19 August 2019

Pearl High School Multipurpose Building

## ADDENDUM NO. 01

# LOWER ROOF FRAMING PLAN

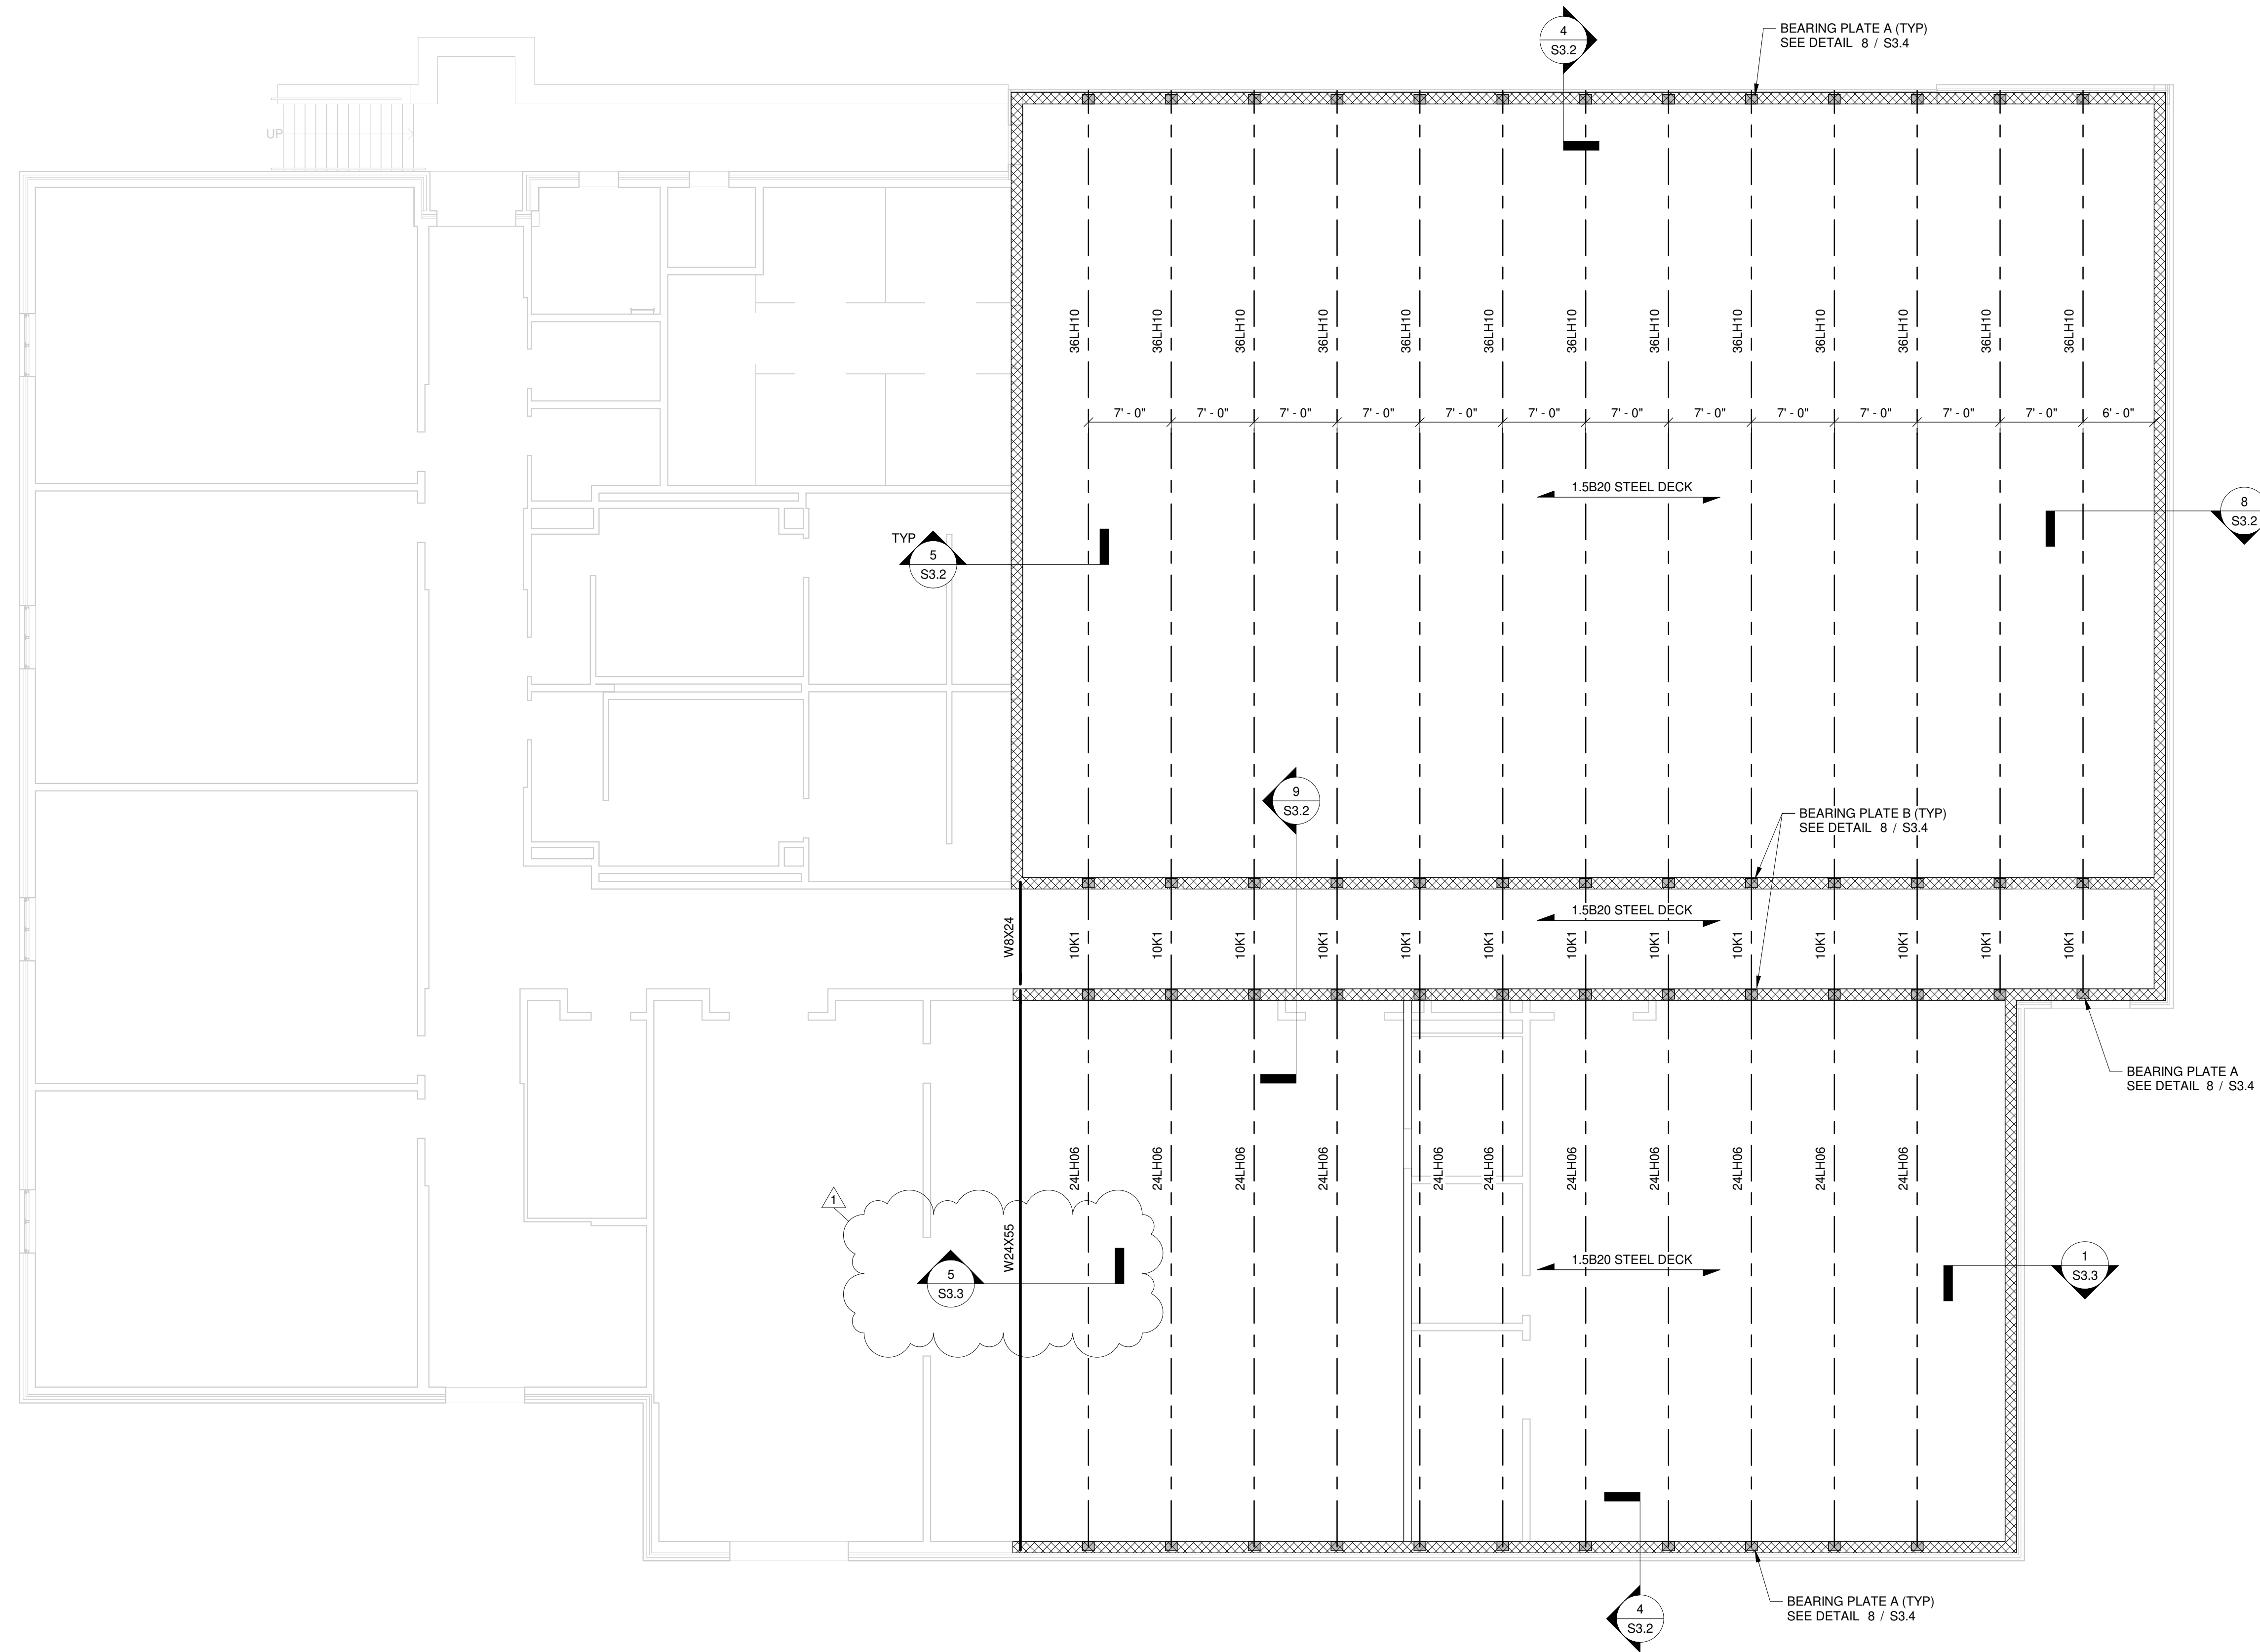
- ITEM NO. 55**      **SHEET S2.1 CMU WALL PLAN**  
*REPLACE* sheet with attached revised sheet **S2.1**.  
Revises CMU wall reinforcement.
- ITEM NO. 56**      **SHEET S2.2 LOWER ROOF FRAMING PLAN**  
*REPLACE* sheet with attached revised sheet **S2.2**.  
Revises roof joist sizes and RTU support framing.

**UPPER ROOF FRAMING PLAN**

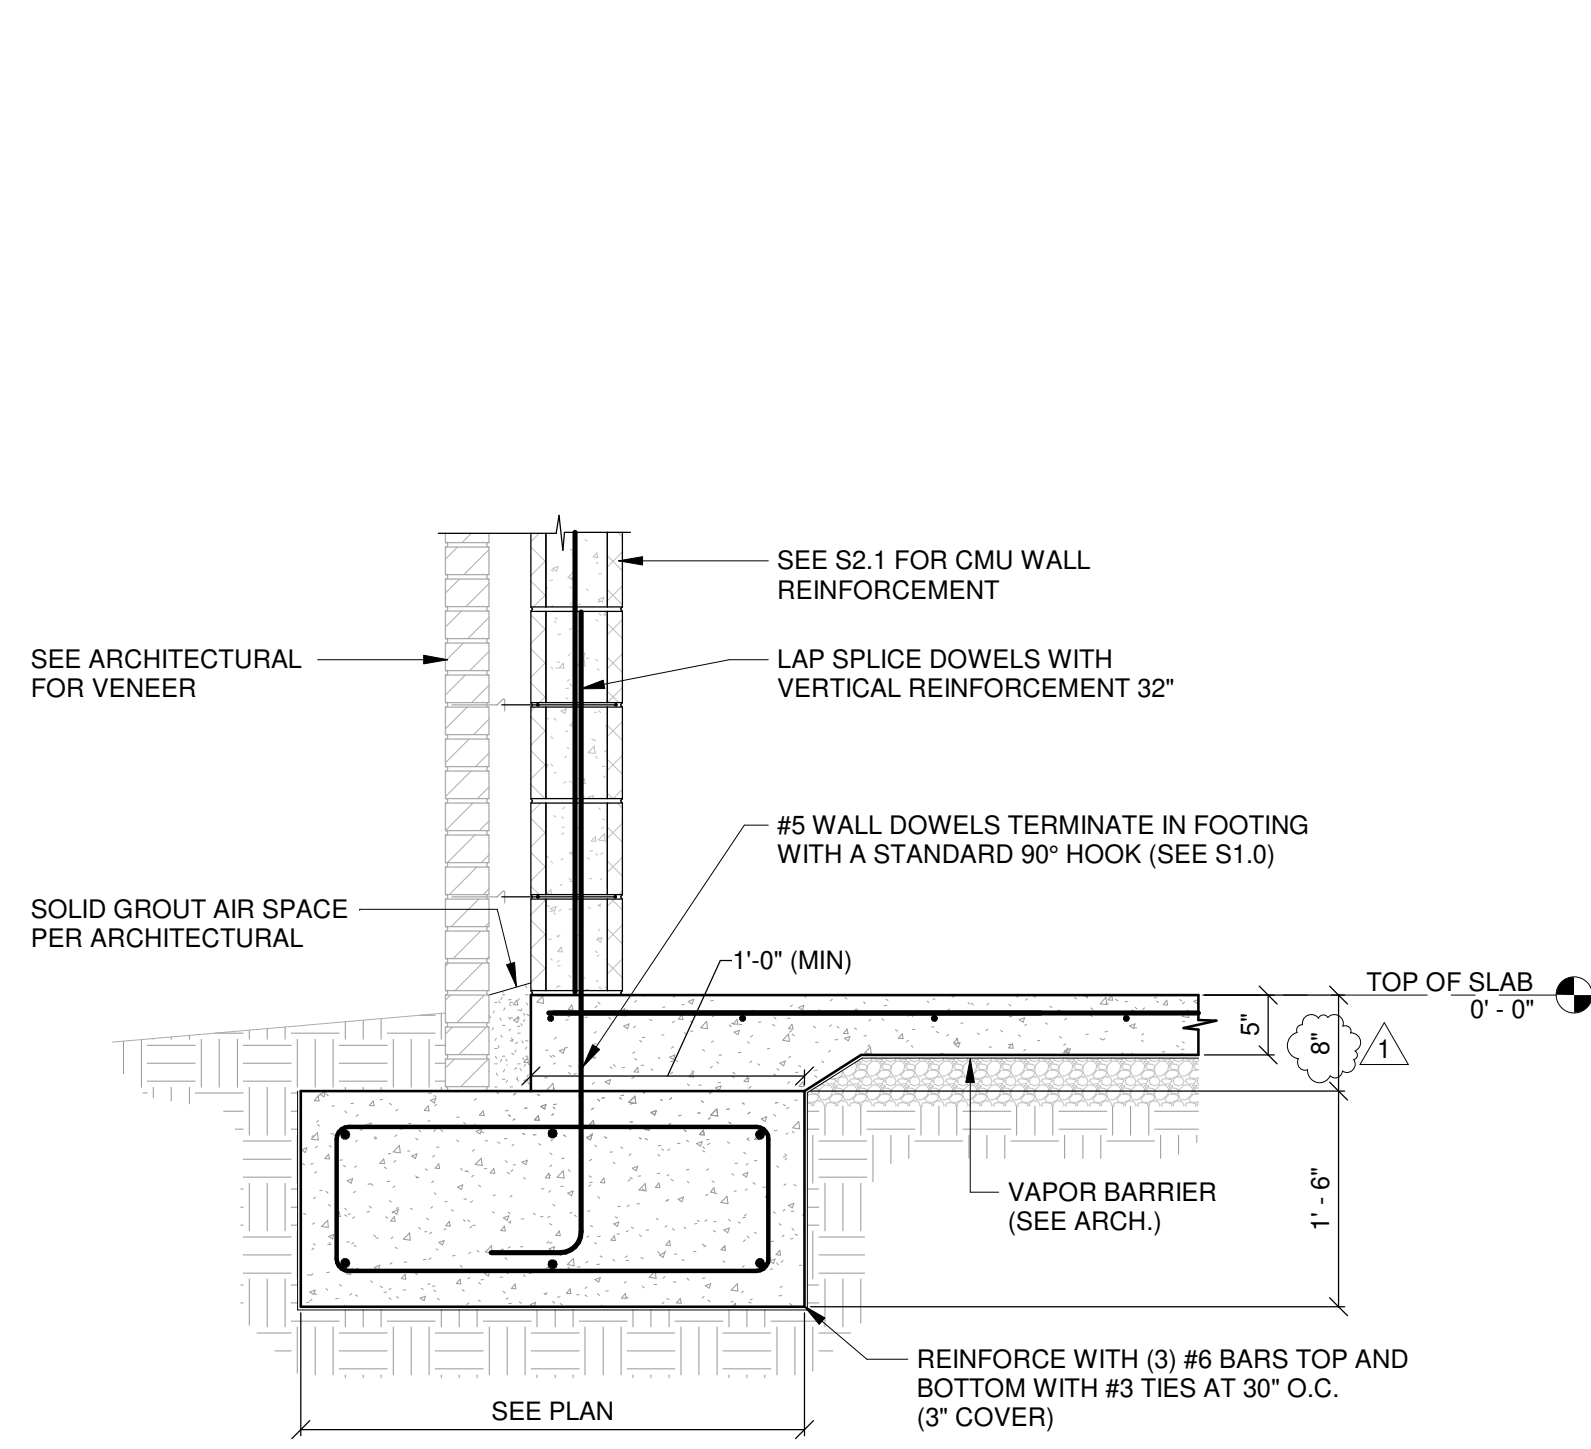
- ITEM NO. 57**      **SHEET S2.3 UPPER ROOF FRAMING PLAN**  
*REPLACE* sheet with attached revised sheet **S2.3**.  
Adds section at steel beam location.

**4**  
S3.0  
INTERIOR FOOTING SECTION AT LOAD BEARING CMU WALL  
3/4" = 1'-0"

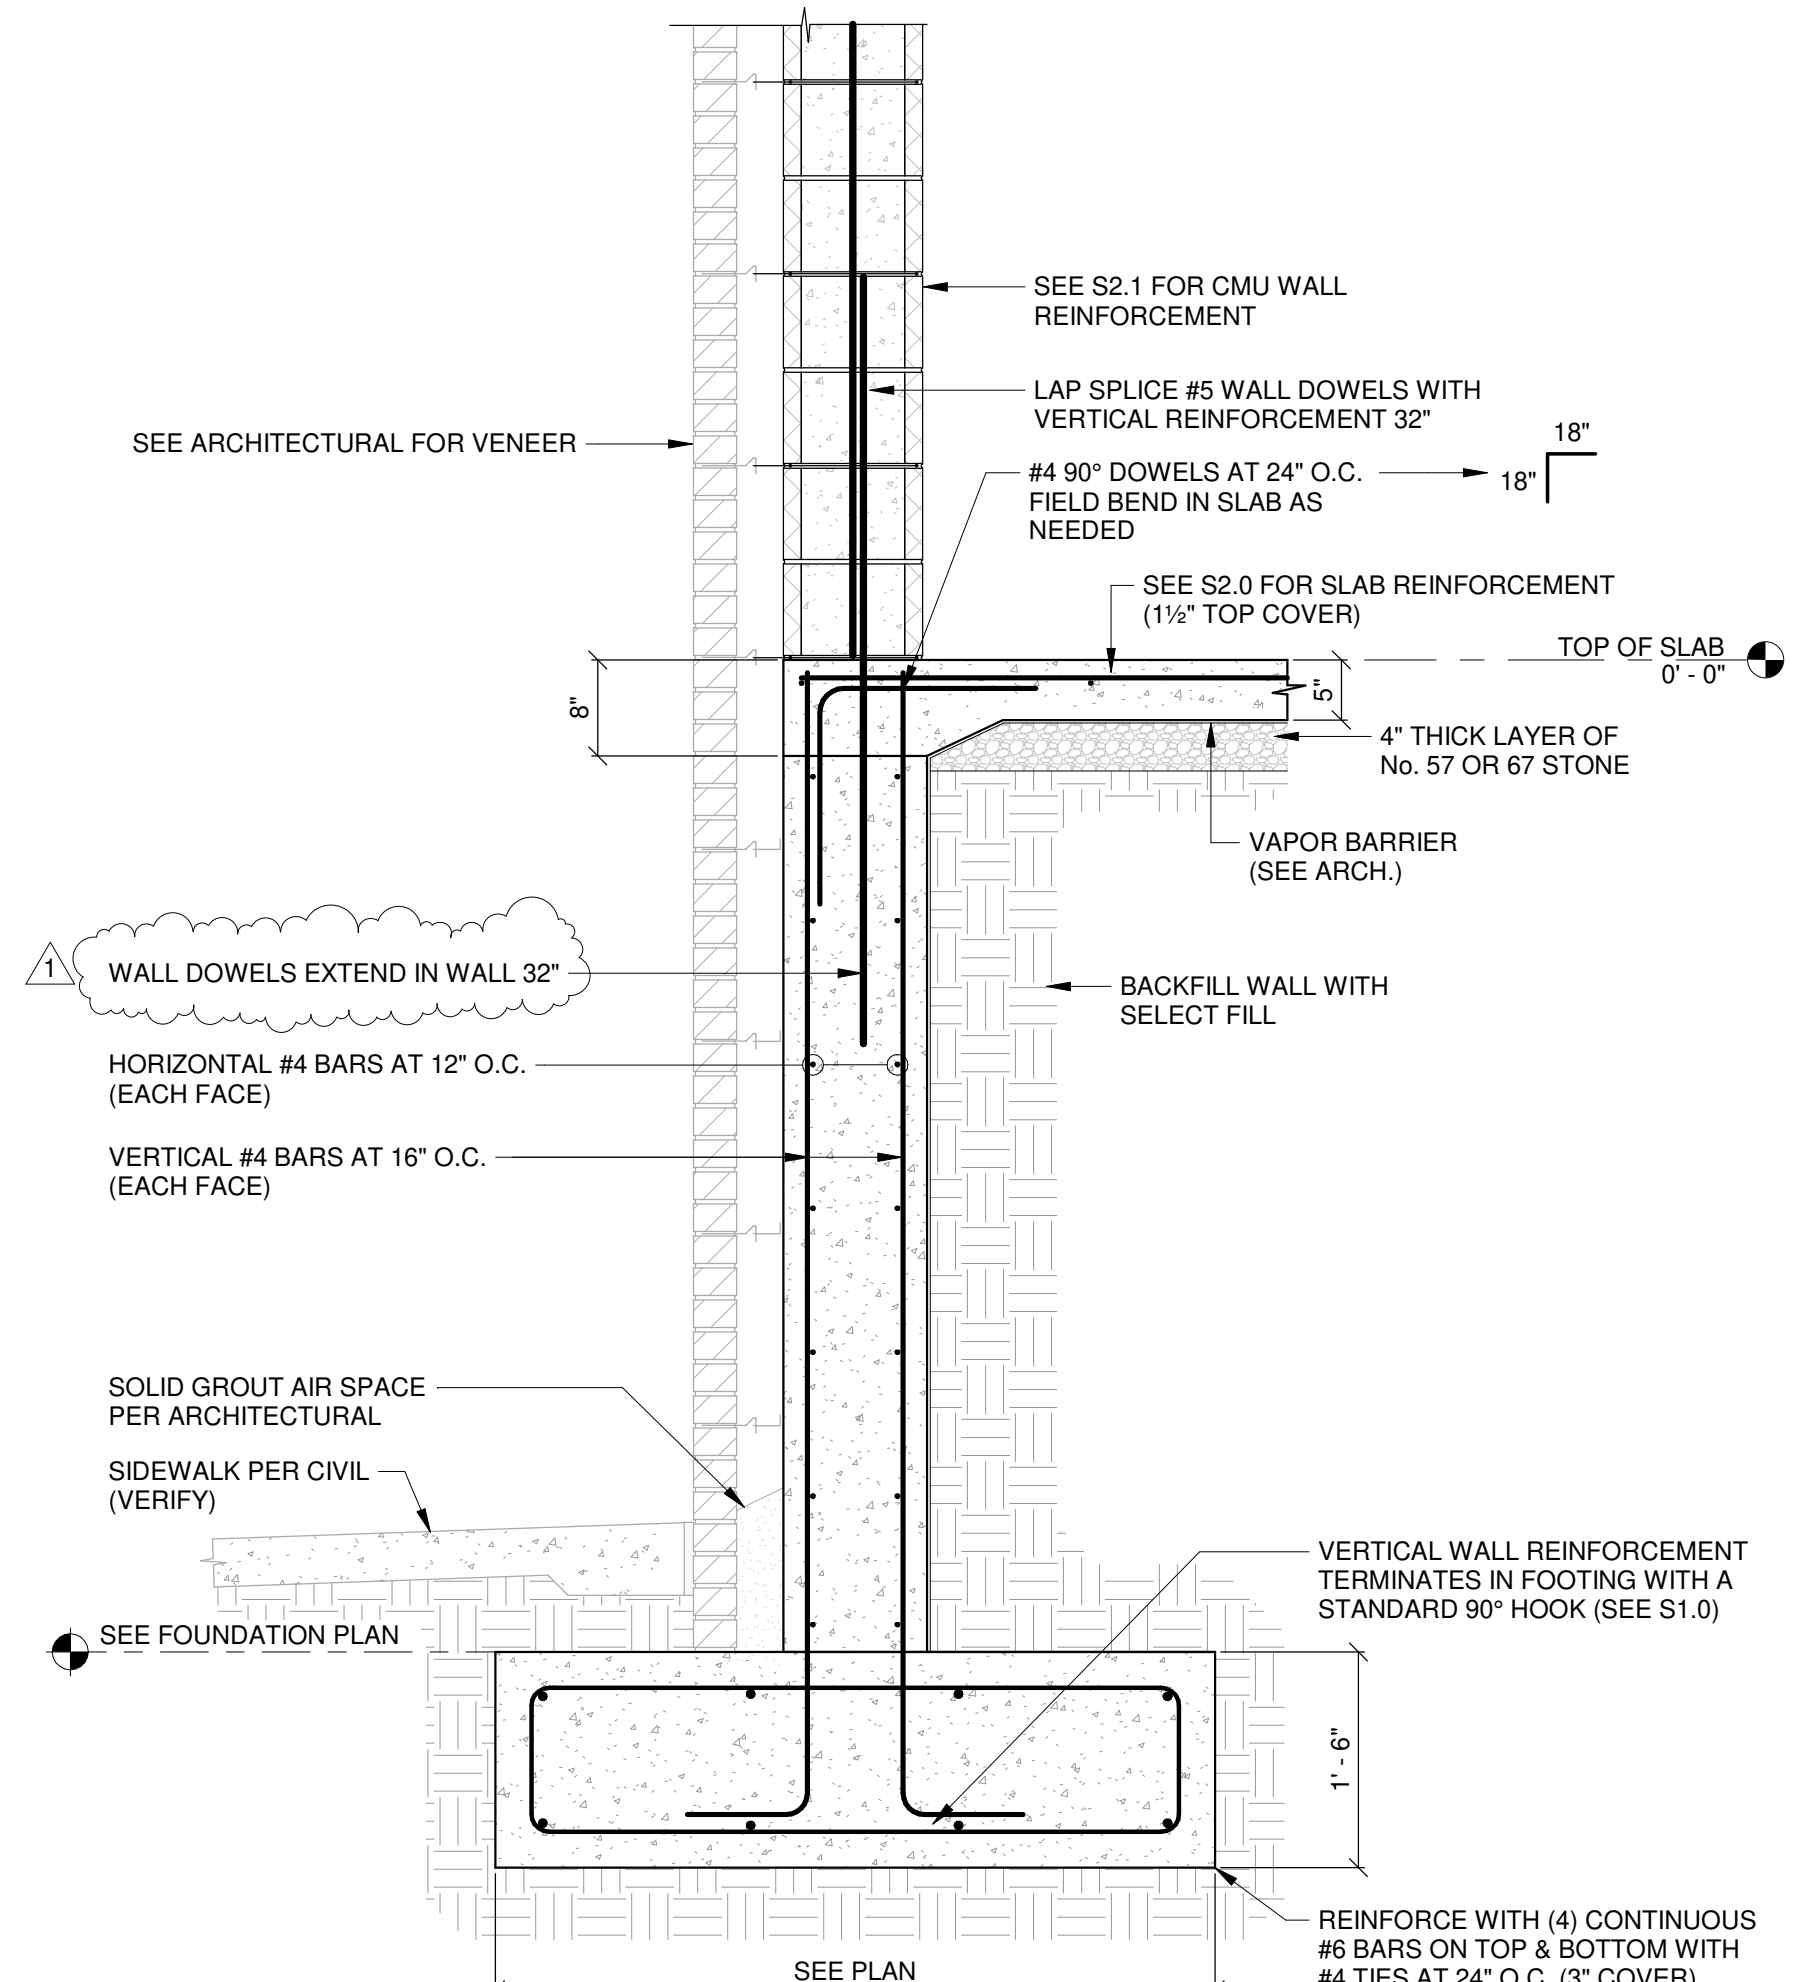
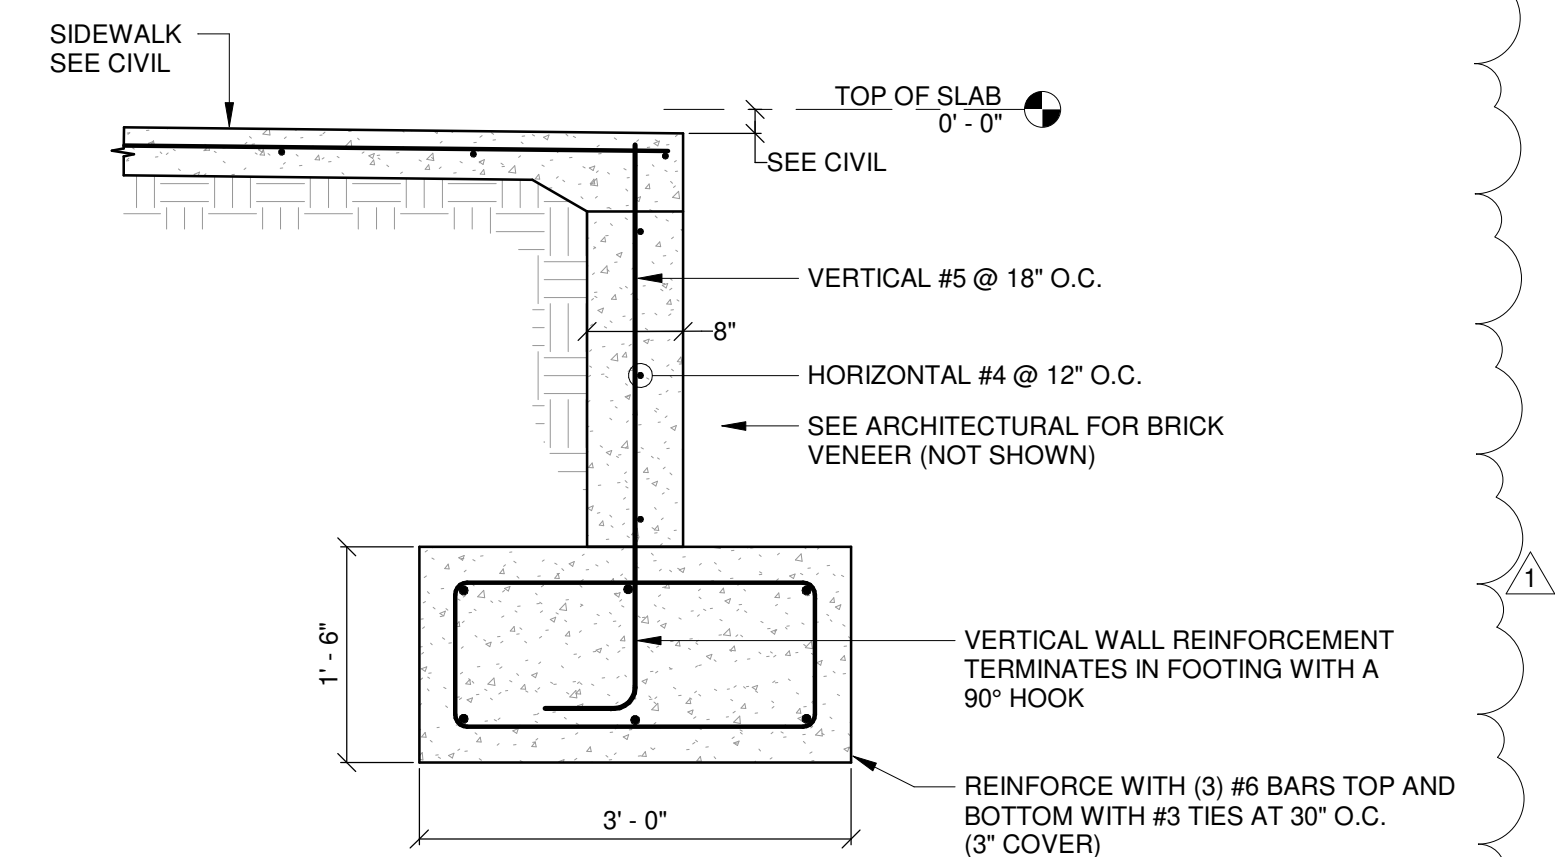
- ITEM NO. 58**      **SHEET S3.0 DETAILS**  
*REPLACE* sheet with attached revised sheet **S3.0**.  
Revises details 4 & 5.  
Adds detail 6.
- ITEM NO. 59**      **SHEET S3.1 DETAILS**  
*REPLACE* sheet with attached revised sheet **S3.1**.  
Adds details 7, 8, & 9.
